Document	EPA Response to Comments from General Electric Company on Engineering Performance Standards – Public Review Copy Hudson River PCBs Superfund Site
Document Date	October 10, 2003

Figure 3-21
Total PCBs Grouped by Total Organic Carbon

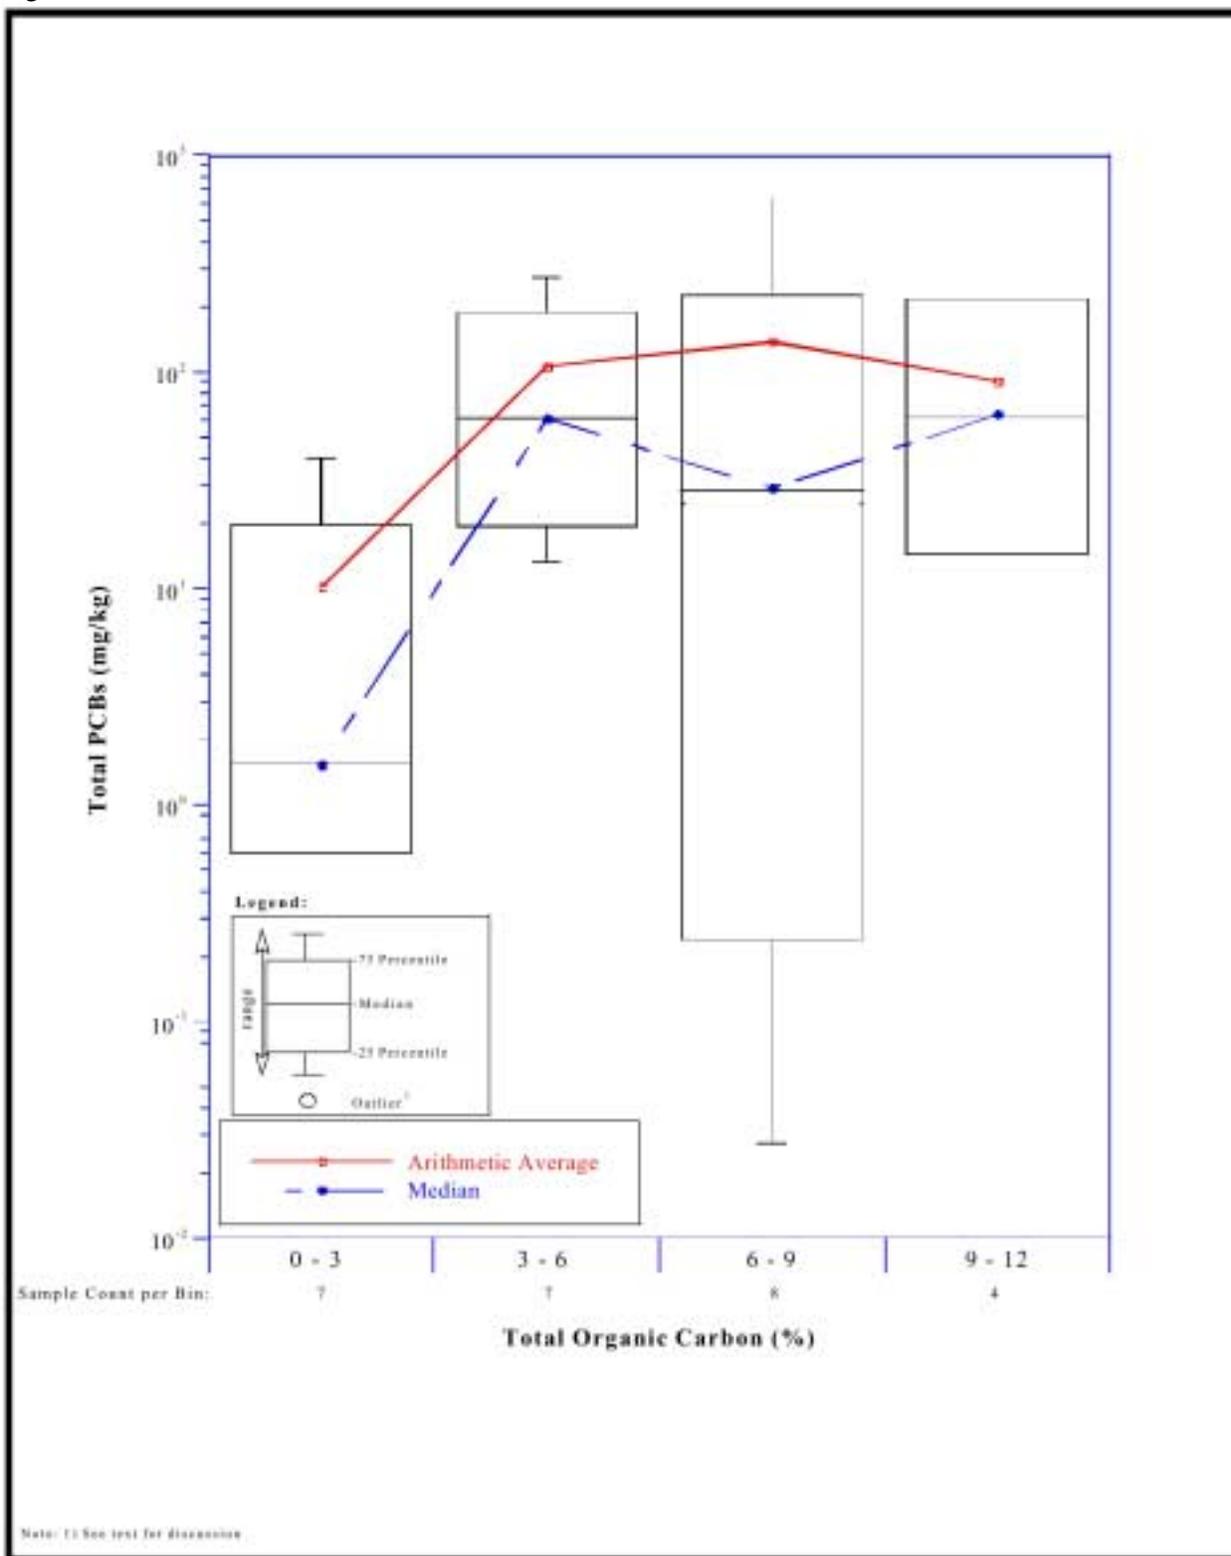
Further support of the lack of a direct correlation between organic carbon content and PCB concentration can be seen in Figure 3-21 of the Low Resolution Sediment Coring Report (USEPA, 1999), which shows that PCB concentration does not increase linearly with TOC and that significant variation can be found at any organic carbon concentration.

USEPA agrees that there may be some enhancement of PCB concentration with smaller particles, but it is not clear that the

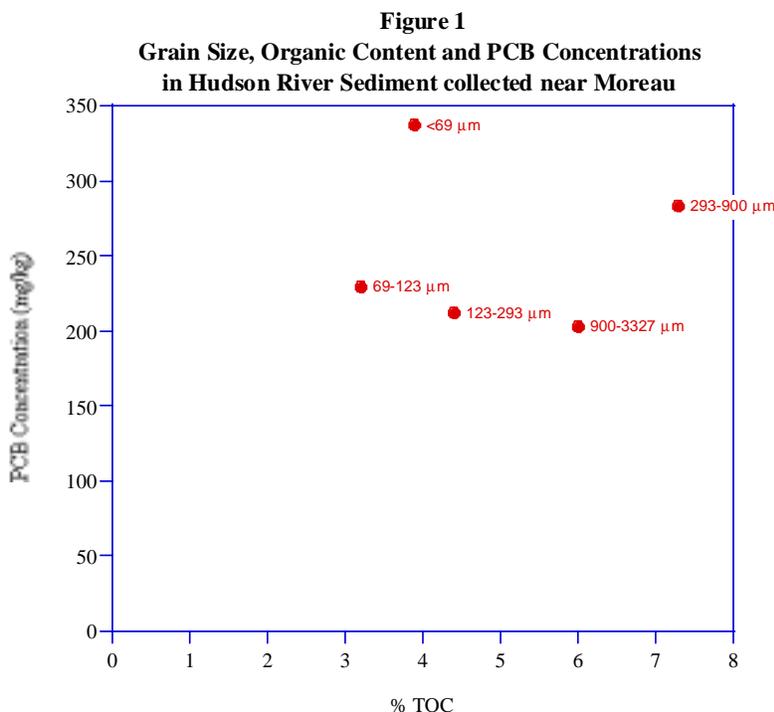
According to a study of contaminated Hudson River sediments conducted by General Electric Corporate Research and Development and MIT published in Environmental Science and Technology (Carroll et al, 1994) the Hudson River sediments greater than 0.069 μm (sand) had % TOC values from 3.2 to 7.3 while the sediments less than 0.069 μm (silt/clay) had a %TOC value of 3.9, indicating little if any difference. These data suggest that the organic carbon content is relatively homogeneous in fine-grained sediments. The data set presented in the paper represents a limited number of samples so it is unclear how far this data can be extrapolated. Nonetheless, it indicates that organic carbon content may not vary with grain size fraction in fine-grained sediments. Furthermore the PCB concentrations for these sediment fractions did not substantively differ. The sand fraction PCB concentrations ranged from 203-284 ppm and the silt/clay concentration was 338 ppm. The data are shown in Figure 1.
